Subject: AP1000 COL Response to Requests for Additional Information (TR 121)

In support of Combined License application pre-application activities, Westinghouse is submitting responses to the NRC requests for additional information (RAIs) on AP1000 Standard Combined License Technical Report 85, APP-GW-GLN-121, Spent Fuel Pool Level and Dose. These RAI responses are submitted as part of the NuStart Bellefonte COL Project (NRC Project Number 740). The information included in the responses is generic and is expected to apply to all COL applications referencing the AP1000 Design Certification.

Responses to Requests for Additional Information on Technical Report No. 121

RAI Response Number: RAI-TR121-CHPB-01  
Revision: 0

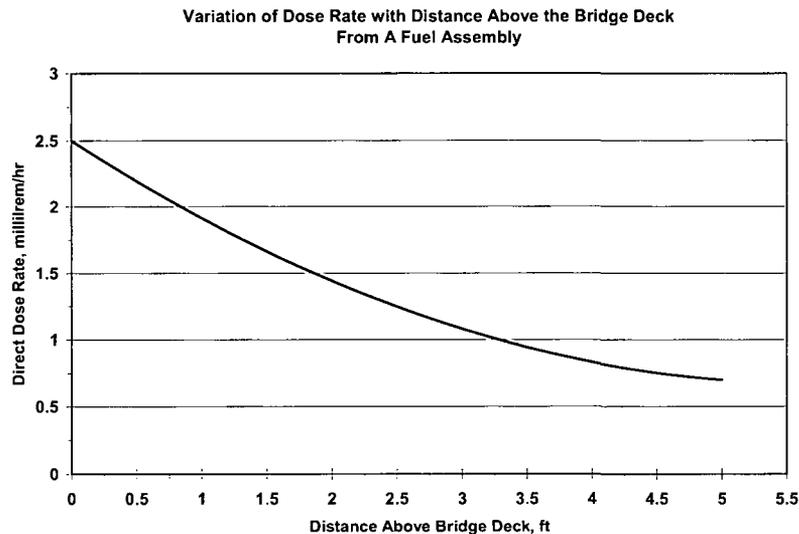
- a. It is not clear from the dose rate curves shown in attachment 5, figure 3 whether these dose rates include not only the dose contribution from the fuel assembly, but also the dose contribution from the radionuclides (corrosion and fission products) contained in the SFP water itself. Verify that these dose curves include dose contributions from both sources. If they do not, provide similar dose curves which include the dose contribution from both sources.
- b. State what effects, if any, these proposed changes will have on the radiation zone designations of the areas surrounding the SFP.

The dose rate curves included in Technical Report 121 are based on the radiation sources associated with a fuel assembly and do not include that from the radionuclides distributed in the spent fuel pit water. The curves that are included in the report are intended to present the capability of the water cover shielding in meeting the design constraint of a maximum of 2.5 millirem/hr in occupied areas. As noted in DCD Section 9.1.3.1.4, a similar design constraint (i.e. less than 2.5 millirem/hr) is imposed on the spent fuel pool purification system design. Note that the combined doses are well below the limit of 20 millirem/hour at the surface of the water during spent fuel transfer specified in the DCD (Section 9.1.4.3.7).

It should also be noted that the **expected** dose rates in the occupied areas (e.g. trolley, bridge deck, edge of operating deck) from both sources are less than 2.5 millirem/hr. This expectation is based on,

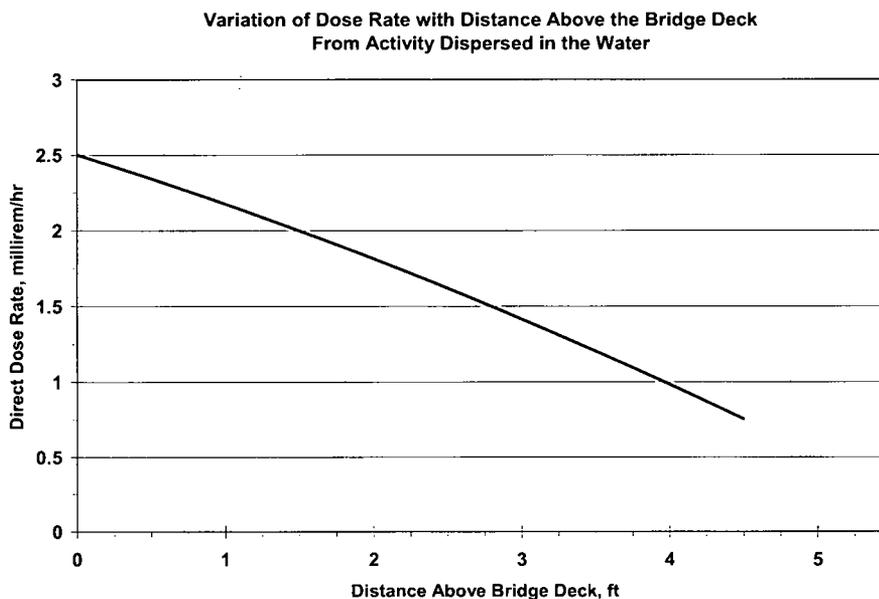
Attachment 5, Figure 3 shows the gamma ray dose rates at various heights over the SFP water surface from a spent fuel assembly which is covered by 114.77 inches of water over the top of active fuel. For this proposed DCD change, the distance between the top of the active fuel and a person standing on the Bridge Deck will be decreased by 18 inches (6 inches less water shielding (by changing the water over active fuel from 10 feet to 9 ½ feet) and 12 inches less air shielding (by raising the level of the SFP water by 12 inches)).

Further, even if the worst-case scenario is assumed (i.e. using the SFHT to move an assembly with the highest source strength coupled with water that has a concentration of 0.005 microcuries/gram), the TEDE dose rate to the worker is determined to be less than 2.5 millirem/hr. As shown in the following figure, the dose rate above the bridge deck due to the fuel assembly decreases with distance.
